Waterview Commercial Investors, LLC  
Preliminary Subsurface Soils Investigation  
Powers Boulevard and Bradley Road  
El Paso County, Colorado

# Soils and Geo Report V1.pdf Markup Summary

TEST BORING LOCATION MAP  
WATERVIEW EAST DEVELOPMENT  
COLORADO SPRINGS, CO.  
FOR: WATERVIEW COMMERCIAL INVESTORS, LLC

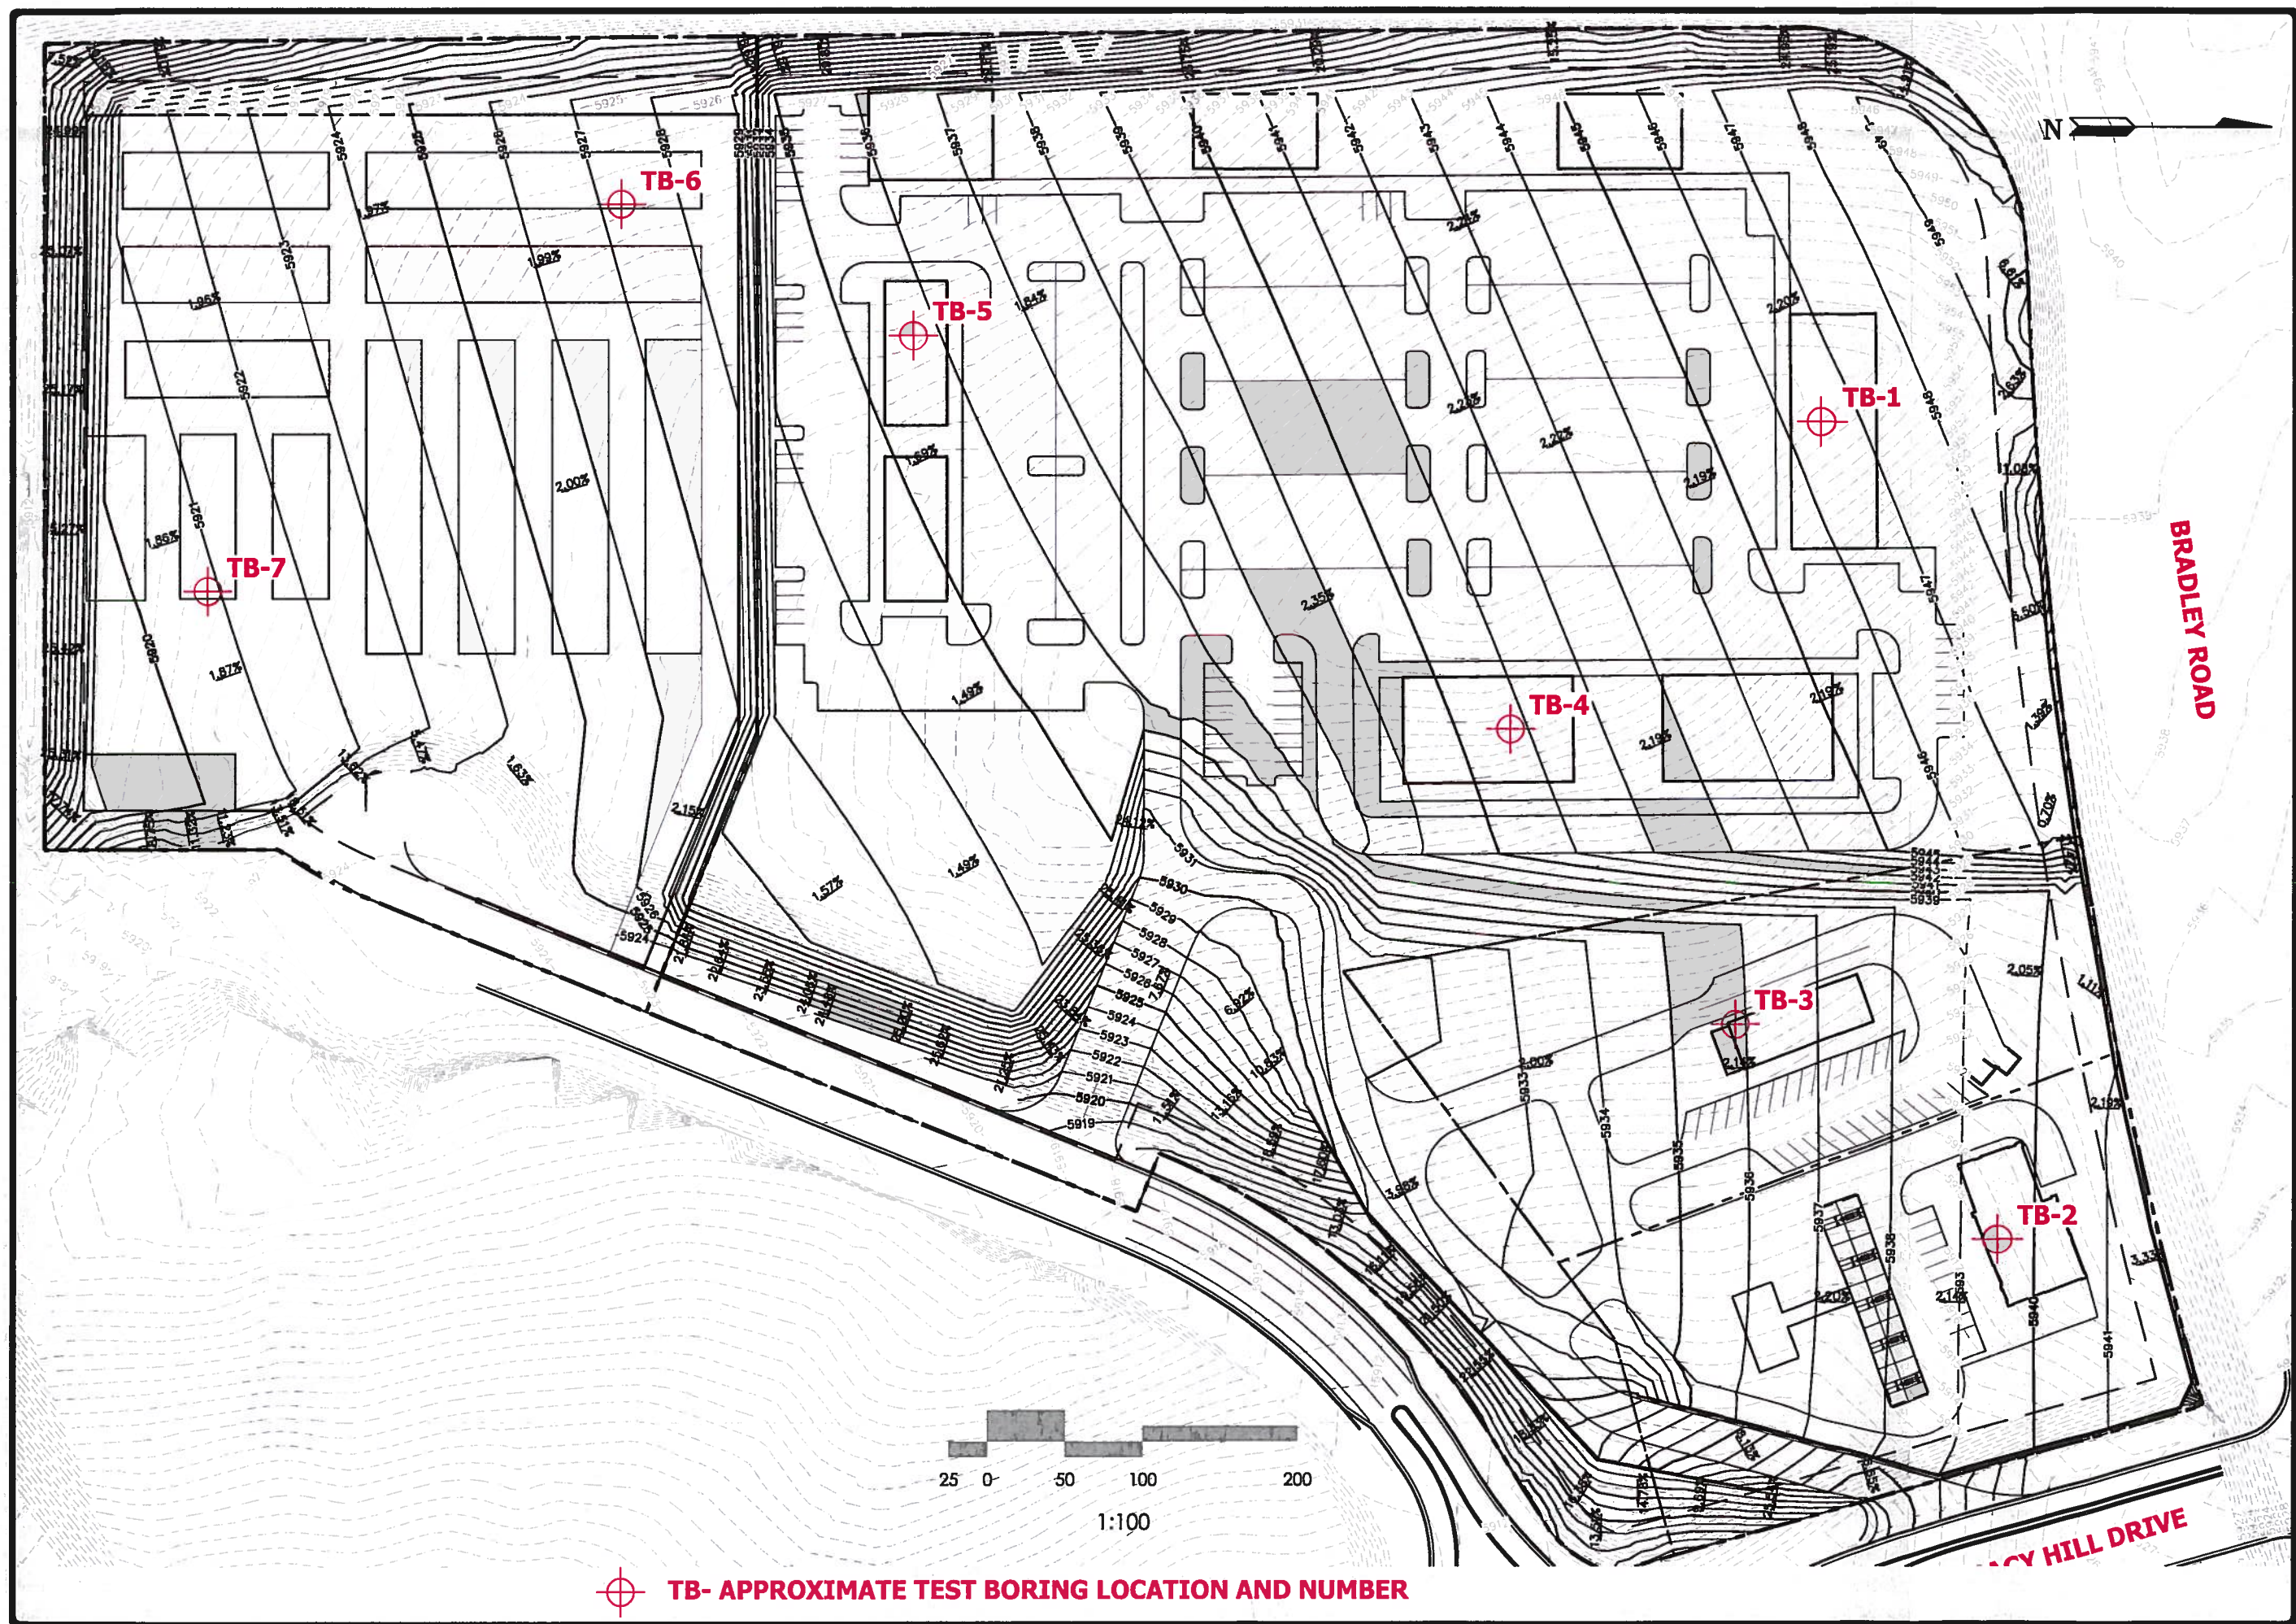
Update the test boring location map to show the current proposed grading and show the three pond locations. Ponds within Tract C and Tract D appear to include embankments. Tract D pond also appears to have a retaining wall adjacent to the pond.

Provide a section regarding detention ponds and address Drainage Criteria Manual sections 11.2.2. and 11.3.3.
